SERVICE BULLETIN

Service Bulletin No.: DAC1-74-01 Rev 1

Title: Ignition Harness Routing

Figure 1
Left Side View of Engine

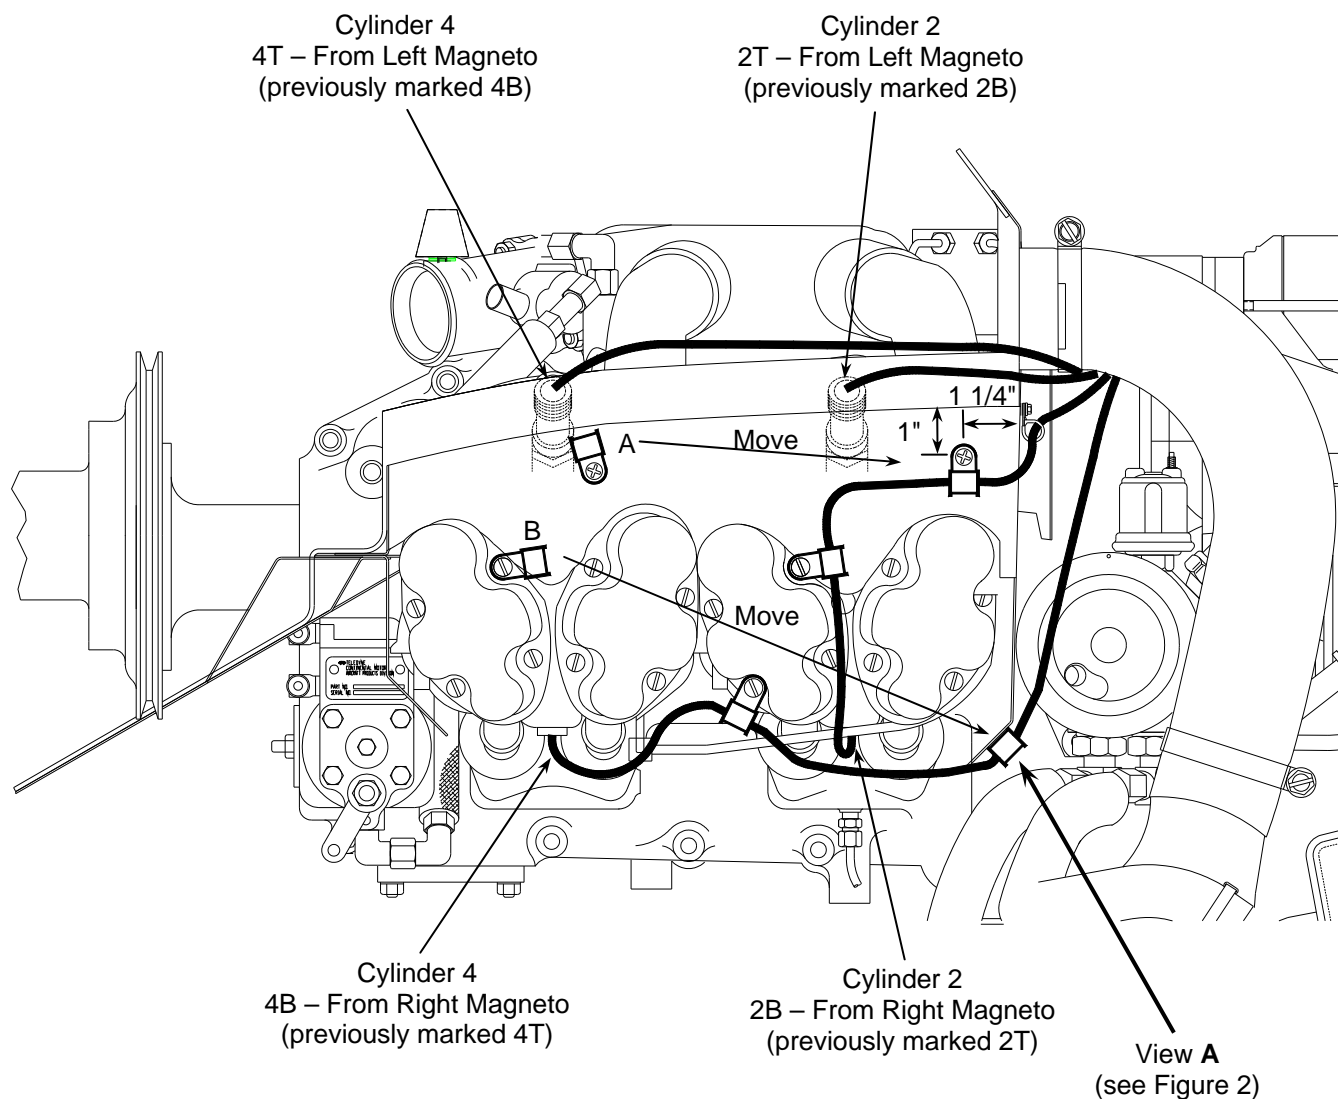
- 10. Accomplishment Instructions:**
 - 10.1** Remove the cable ties from the harness behind the engine (Note the locations).
 - 10.2** Drill a #10 diameter hole 1¼" forward and 1" down from the upper aft corner of the right baffle (Figure 1).

- 10.3** Remove the cable clamp from location A and move it to the new location (Figure 1). The hole at location A may be sealed with suitable hardware or left open (cooling air leakage is negligible).

- 10.8** Reroute the harness as shown in Figure 1 and 3.

10.9 Re-identify the ignition harness as shown in Figures 1 and 3. Vibropeen an "X" through the original lead location and on an adjacent nut flat Vibropeen the new location. As an example, number 4 cylinder upper lead will be changed from "4T" to "4B".

Figure 2
View **A** from Figure 1

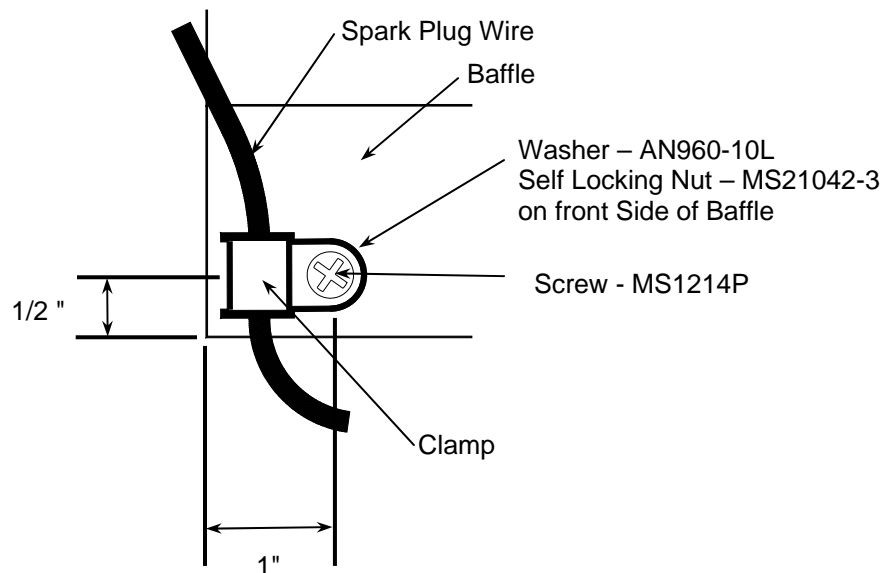
- 10.4** Drill a #10 diameter hole 1" inboard and ½" up from lower left corner of the aft baffle (Figure 2).
 - 10.5** Remove the cable clamp from location B and move it to the new location (Figure 1). Use suitable hardware (Figure 2).
